Planning Commission

TO: Planning Commissioners
FROM: Katie Peterson, AICP, Senior Planner
RE: Review of Revised Plans to COFA-03-23-017836
DATE: 10/25/2023
CC: Kevin Icard, AICP, Director of Growth Management

RE: Big Blue Marble Cypress Ridge – Planning Commission Comment Responses

SITE PLAN - PHOTOMETRICS

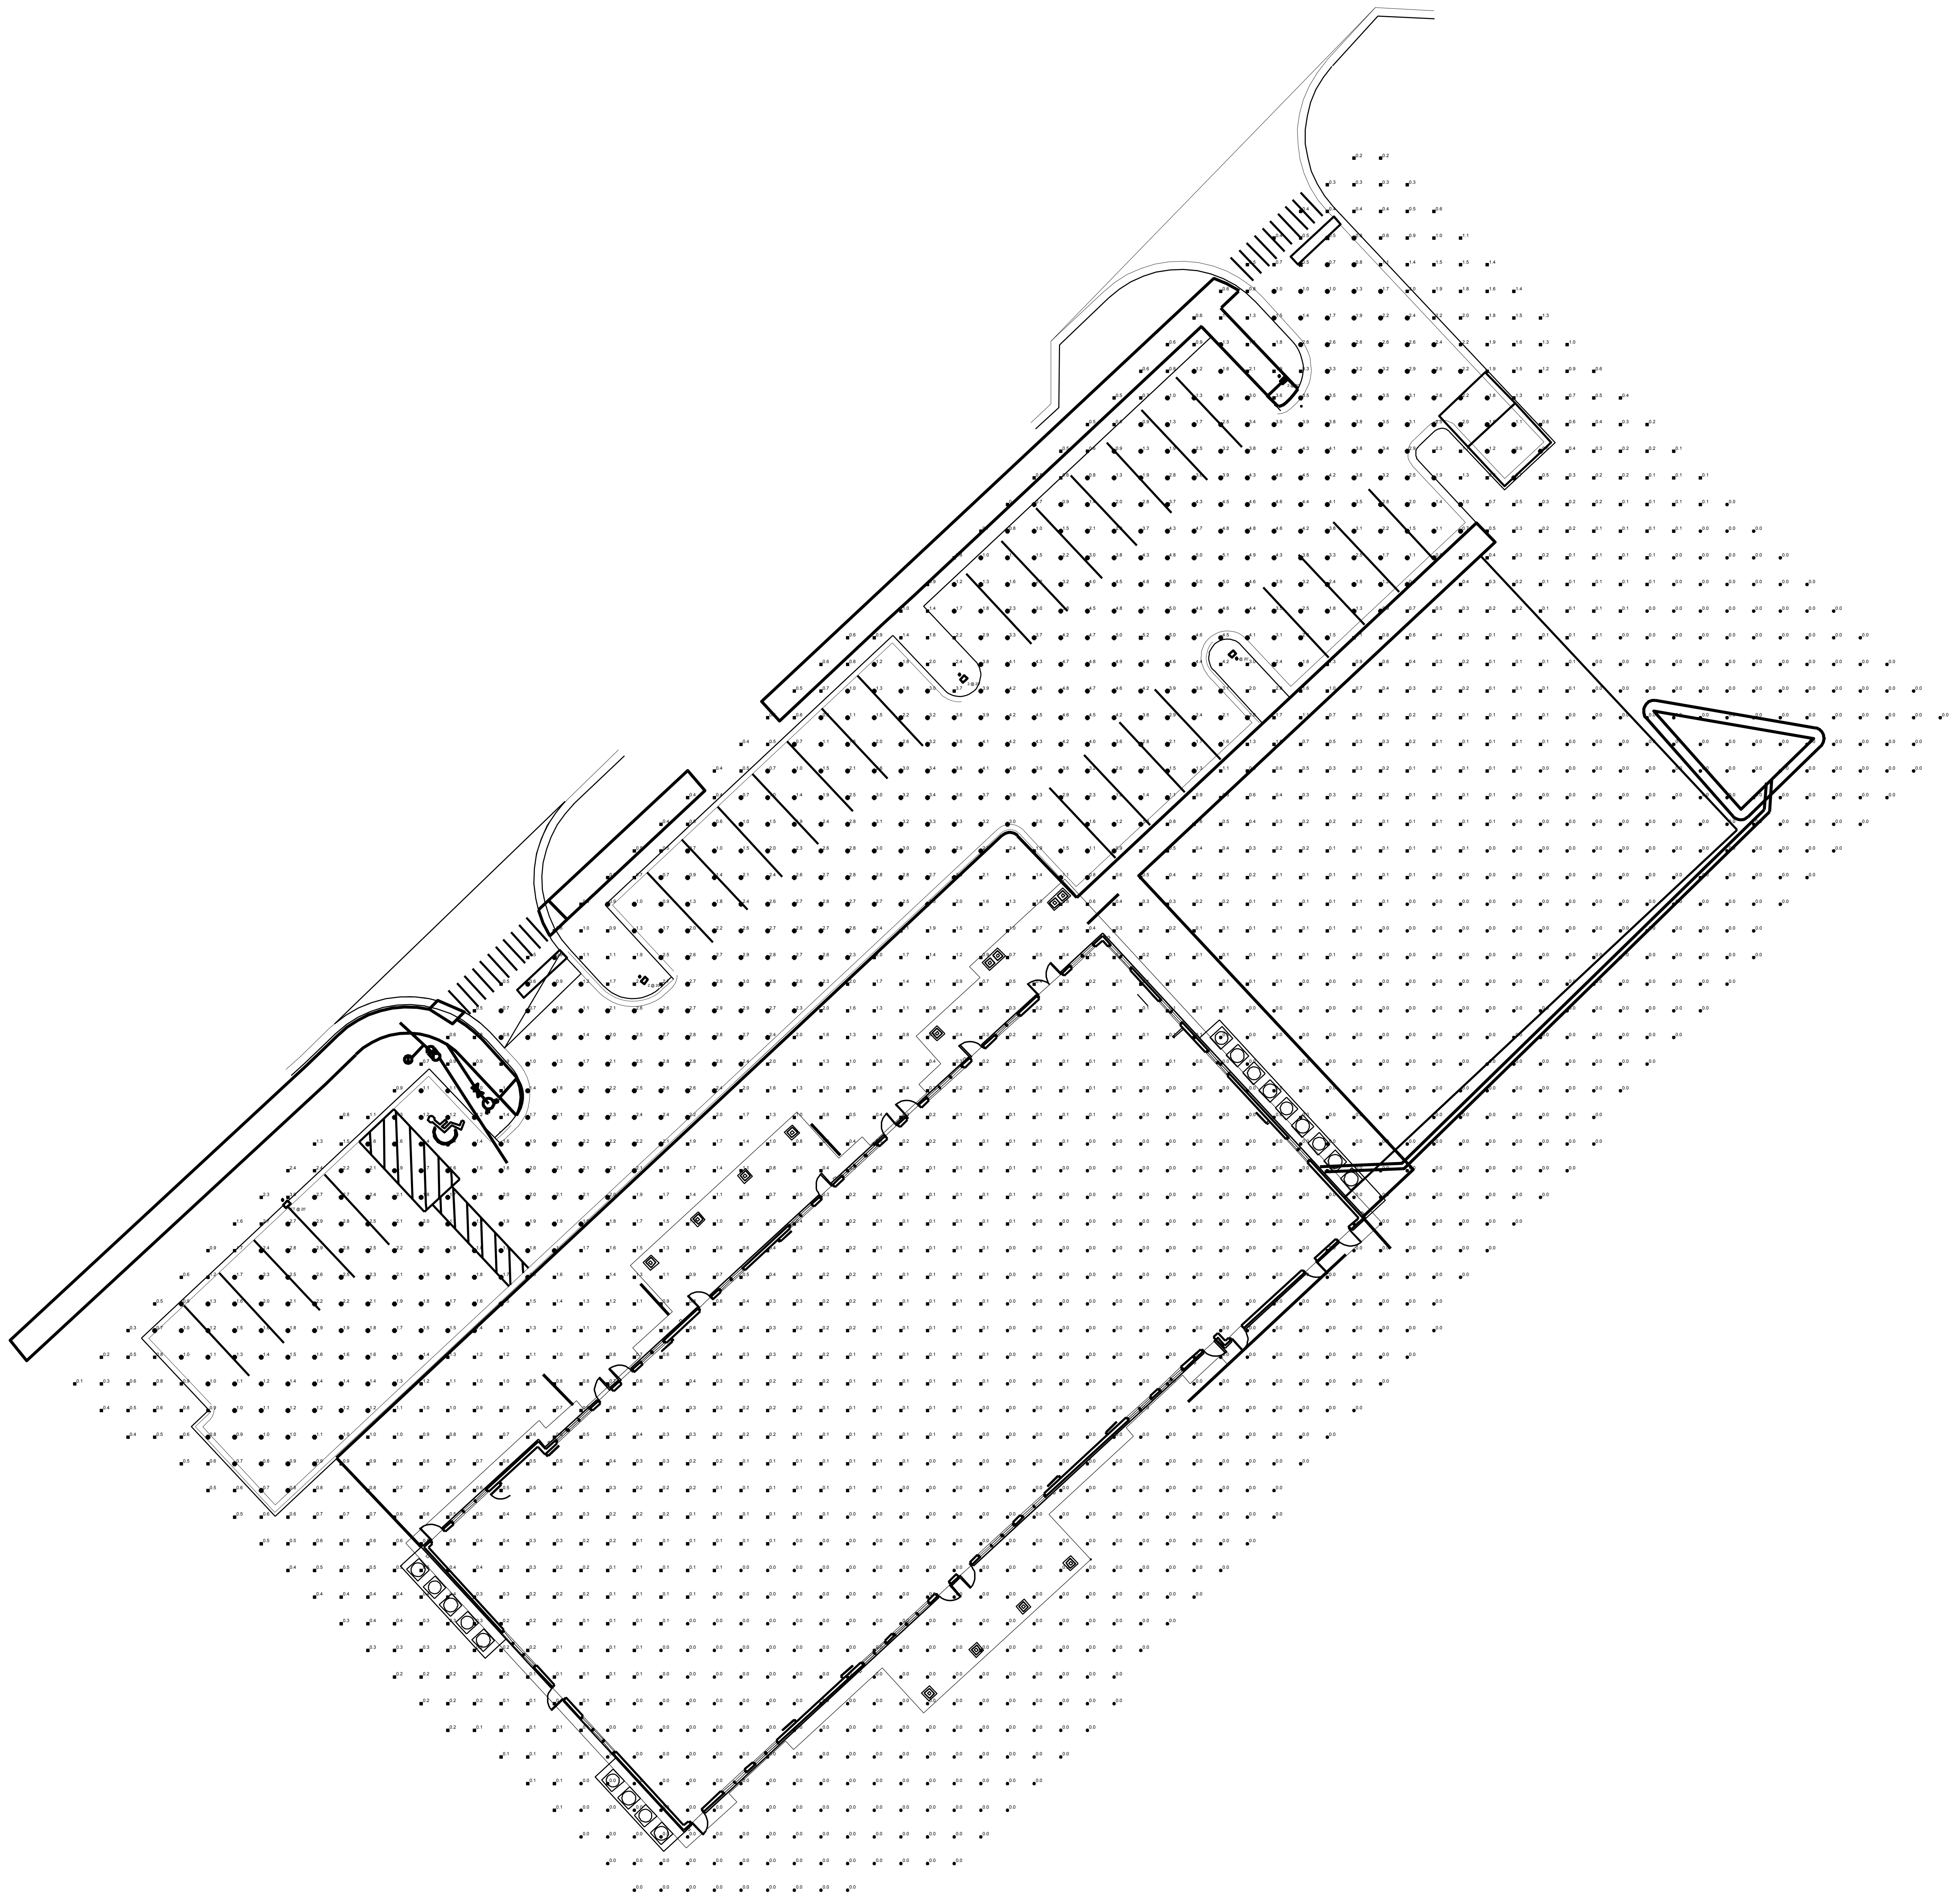
4. Per Section 4.23.3.C.2.a.2.1. of the ZDSO, additional information is required to ensure all fixtures will be cutoff luminaires.
5. All comments must be addressed, and a Final Development Plan must be approved prior to issuance of the Certificate of Appropriateness – HCO.

b. Per Section 4.23.3.C.2.a.2.1. of the ZDSO, additional information is required to ensure all fixtures will be cutoff luminaires. With fully concealed light source.
  - Revised photometric plan provided with additional information on fixtures.
  - Noted and revised on the photometric plan.

1 ROOF PLAN
SCALE: 1/8"=1'-0"

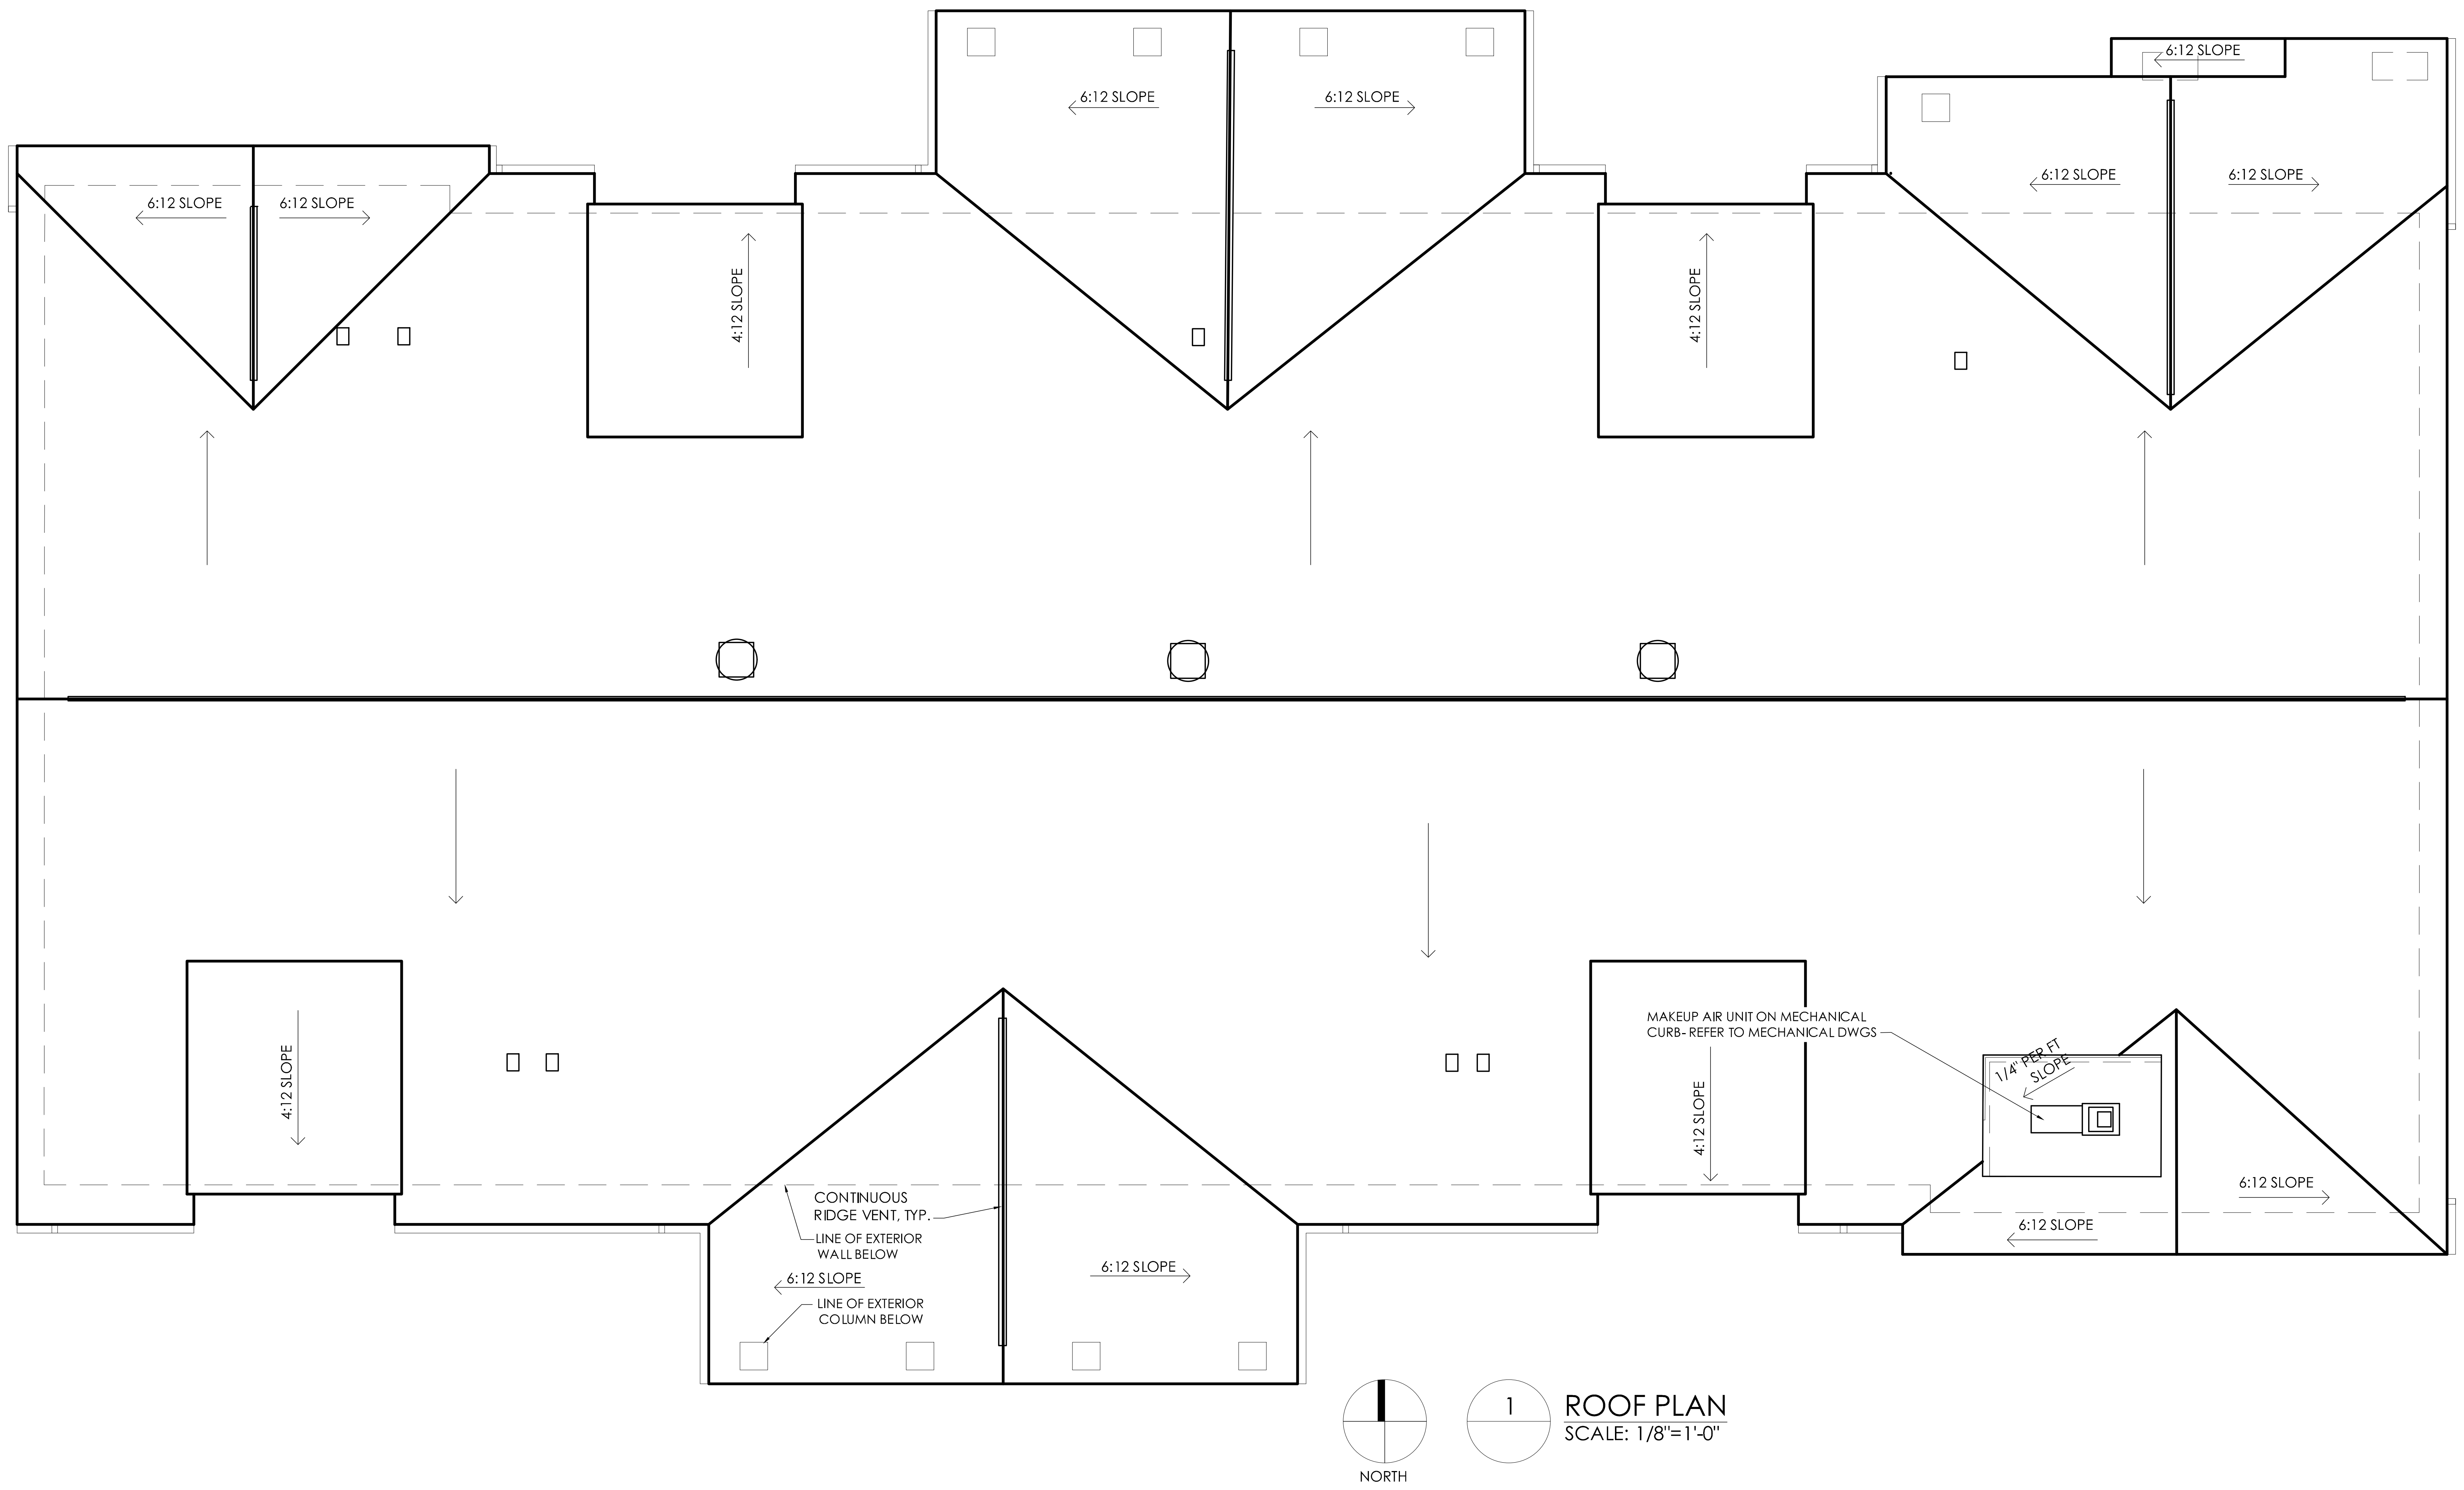
f. Move the three (3) roof ridge vents to the other side of the ridge.
  - The roof ridge vents have been relocated to the other side of the ridge.
